REVIEW OF ENVIRONMENTAL FACTORS

Proposed Residential Flat Building

6-12 Peters Avenue, Wallsend NSW 2287

November 2023

Figure 17 – Cross section through private open space areas (Source: Place Design Group)

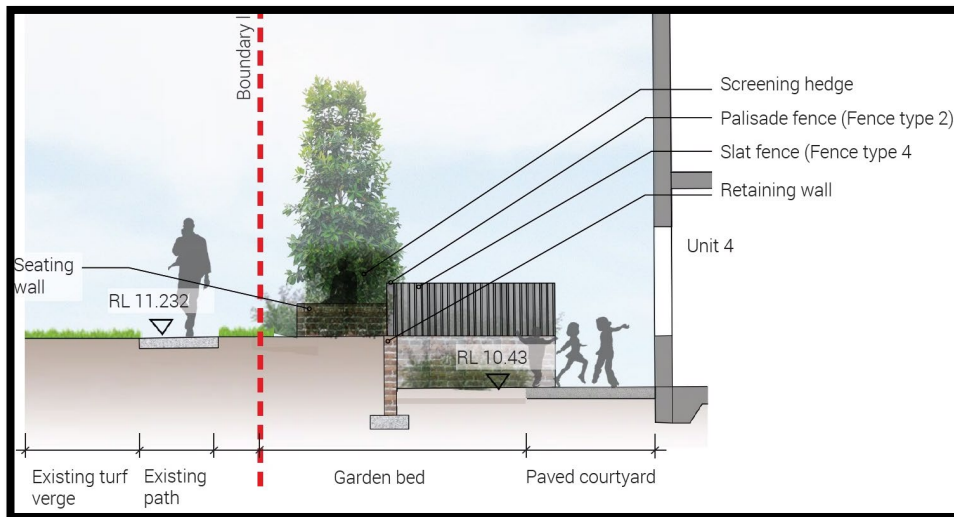
'..the partly screened protruding first floor balconies and the front courtyard areas with solid fencing add to the building bulk and scale and draws the main building form closer to the street and visually presents as a reduced setback overall, varying this section of streetscape substantially.'

Solid fencing enclosing the ground floor private open space areas has been replaced with open style slat fencing. The amended Ground Floor Plan and Street Elevations are included in *Appendix A*.

It is also noted that the ground level private open space areas are sited below ground level, behind open style fencing and 1m high plantings which will screen the spaces and reduce their visual impact. A cross section through the private open space areas at the front of the site is shown in the following detail, extracted from the Landscape Plan:
